ADDENDUM No. 1

Bid No. 25-034

Johnston Road at FPFWCD Canals 16 & 17 Culvert Replacement

May 27, 2025

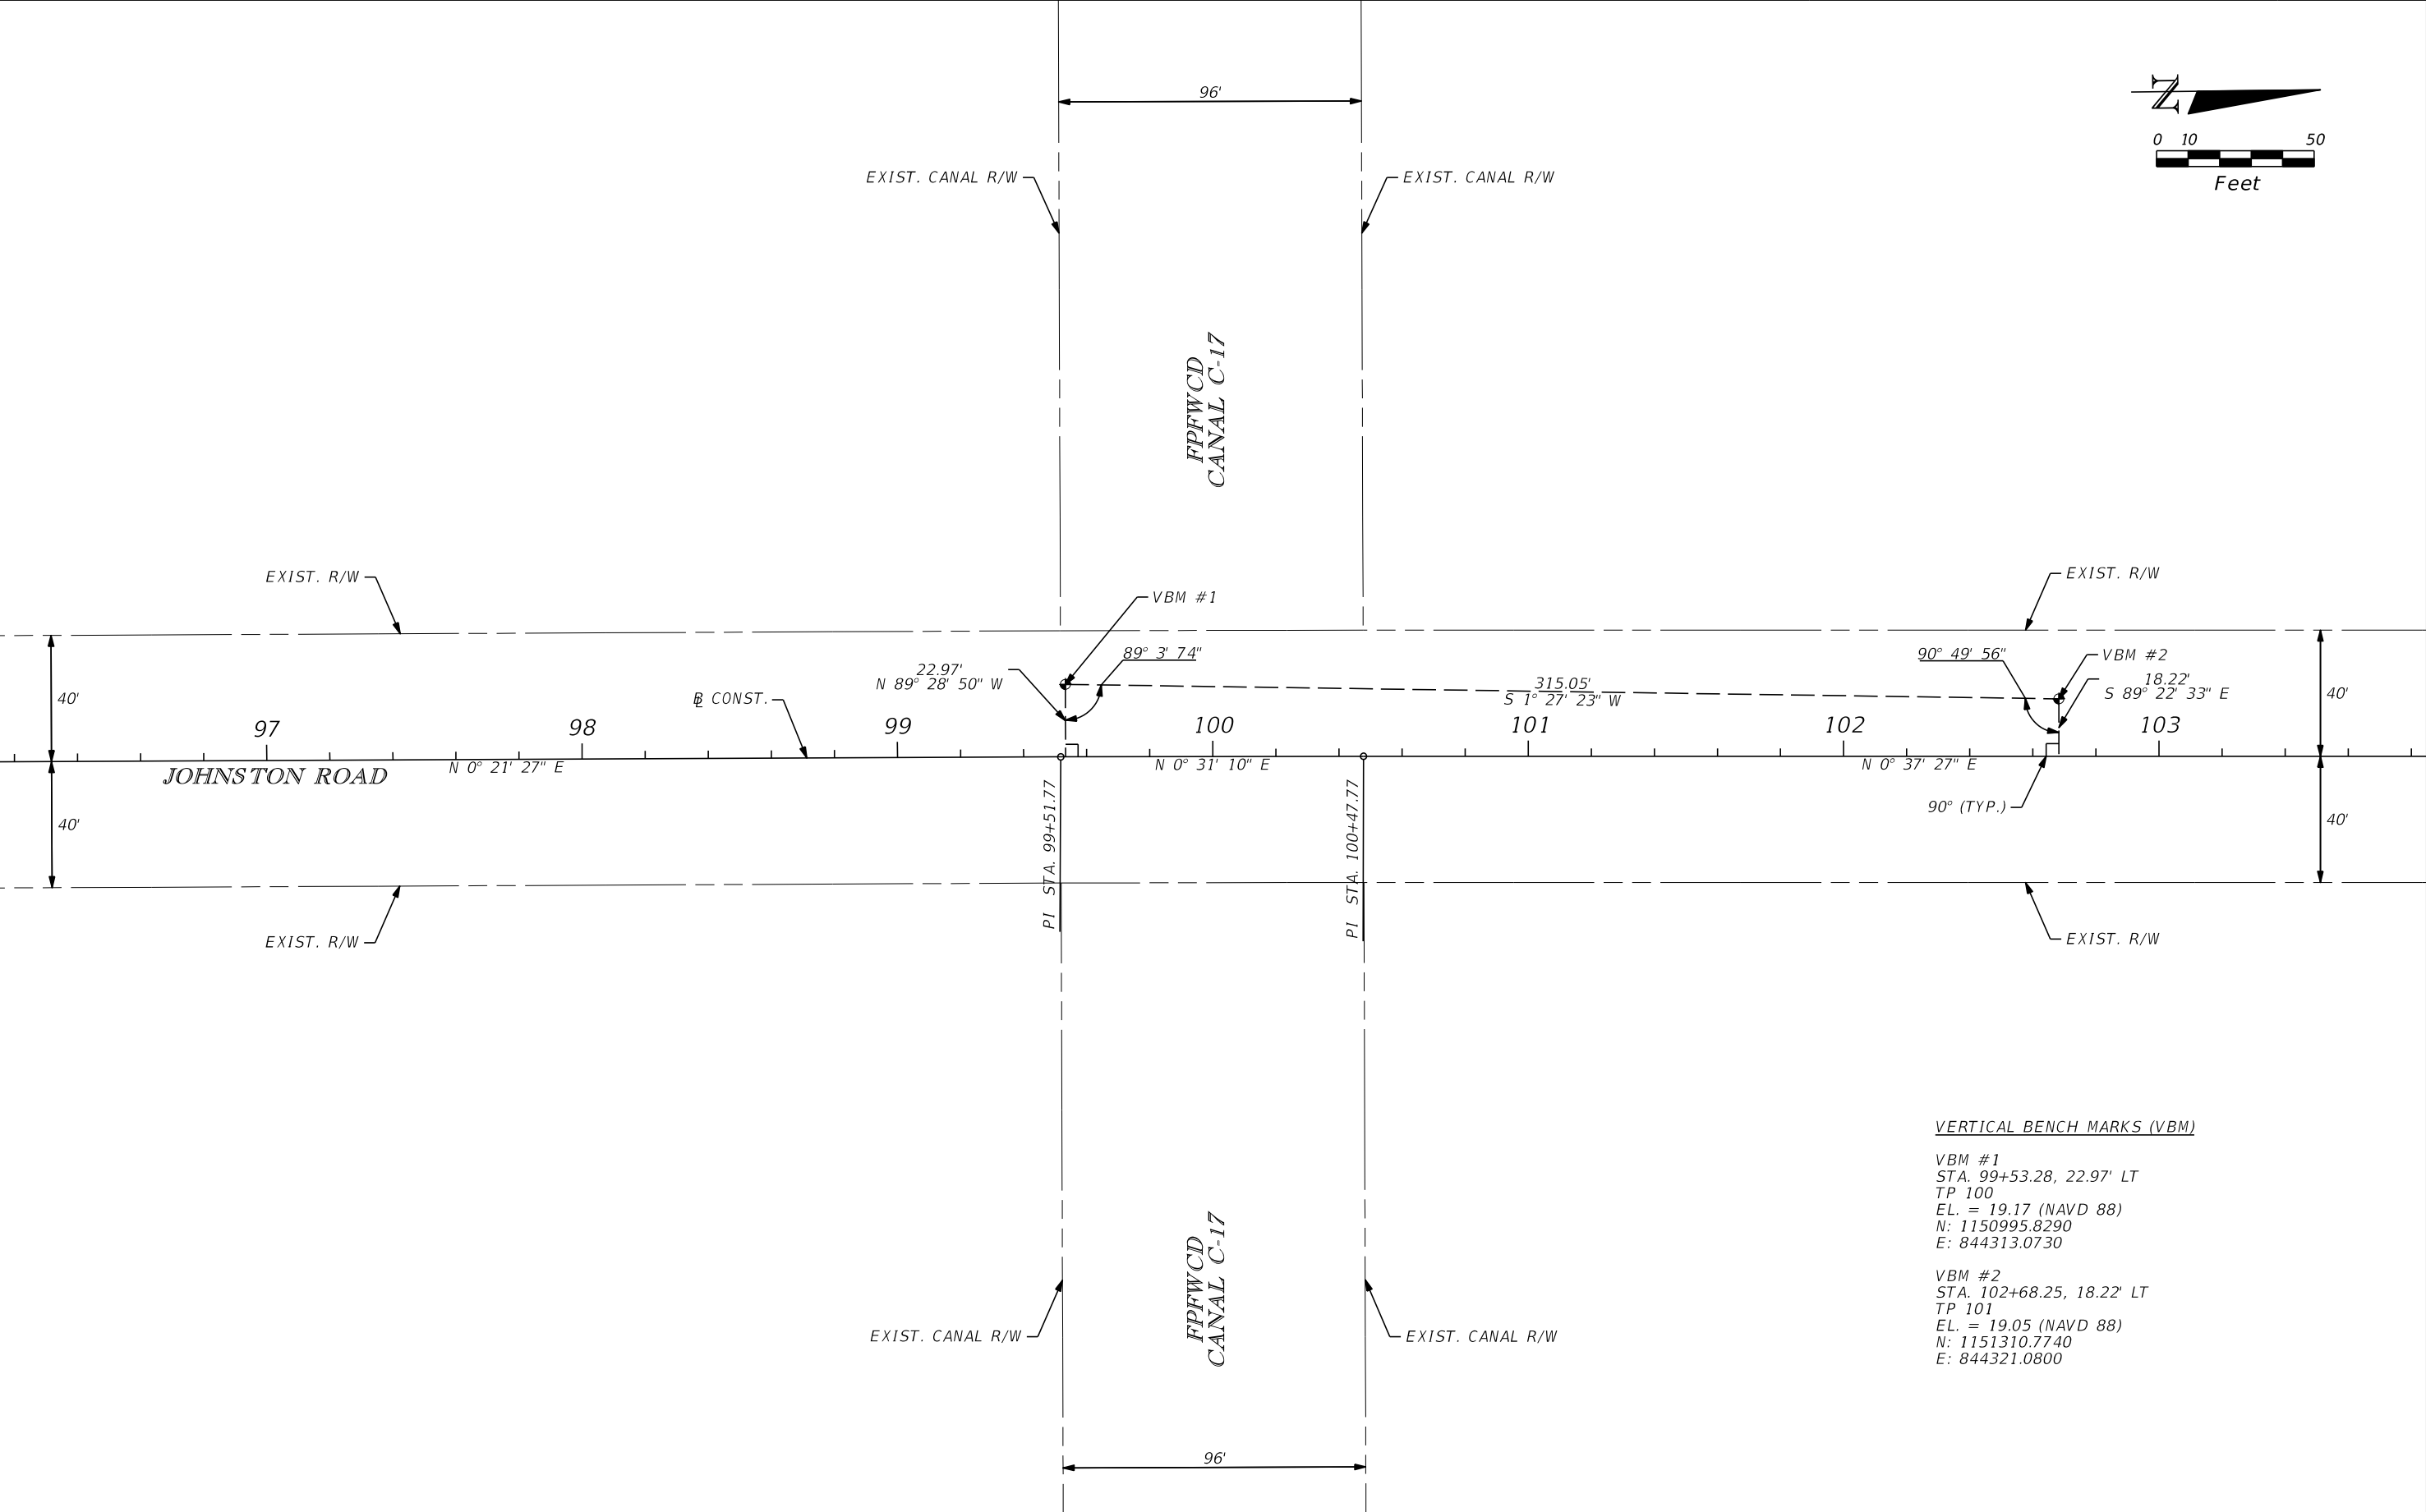
- On Sheet 3, pay item footnotes under 400-80A changed from "27,000 GPM" to 37,000 GPM. Under the same section the EOR eliminated the last sentence stating, "This pay item will not be invoiced if not used" On the same sheet, under the summary of pay items and pay item footnotes the pay item number 400-91 changed to 400-90A Construction Dewatering.

A representative from a Contracting Firm also brought up the fact that the plans stated on Sheet 3 under pay item footnotes 400-80A “this pay item will not be invoice if not used”. Daniel explained the pay item for 400-80A and what all would encompass within that pay item and said he would investigate the language and correct any contradicting notes.

Removed statement
"This pay item will not
be invoiced if not
used"

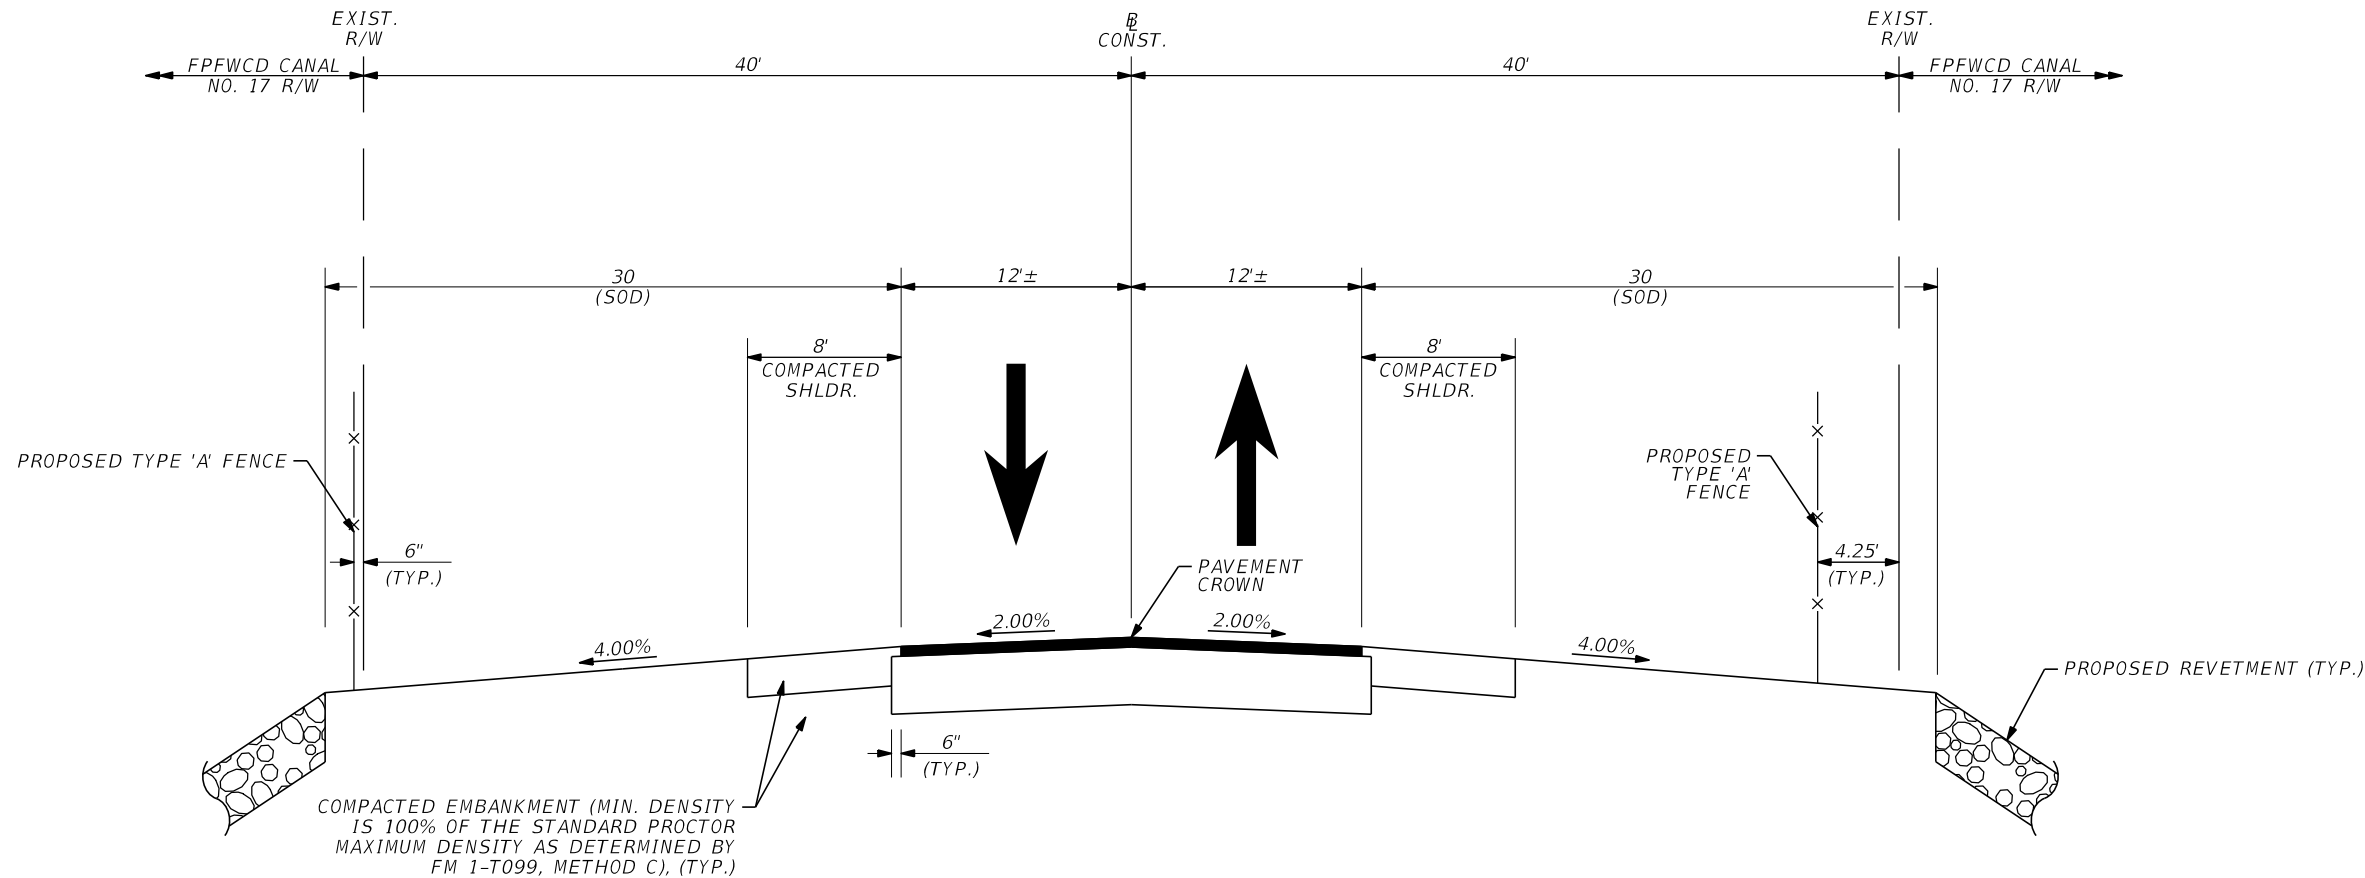
- On sheet 5, under Proposed Construction Phasing we changed just the number under pay item 3 from "item 400-91" to "item 400 – 90A".
 - On sheet 6, under note B on the bottom right, we changed pay item number to 400-80A instead of what is stated as "400-90A"

3.CONSTRUCT TEMPORARY DAMS WITHIN FPFWCD CANAL NO. 17 UPSTREAM AND DOWNSTREAM OF EXISTING CROSS DRAIN UNDER JOHNSTON ROAD. THE METHOD OF CONSTRUCTING TEMPORARY DAMS IS LEFT TO THE CONTRACTOR, BUT MAY CONSIST OF SHEET PILING, EARTHEN BERMS, ETC. COST OF TEMPORARY DAMS SHALL BE INCLUDED WITHIN PAY ITEM 400-90A.
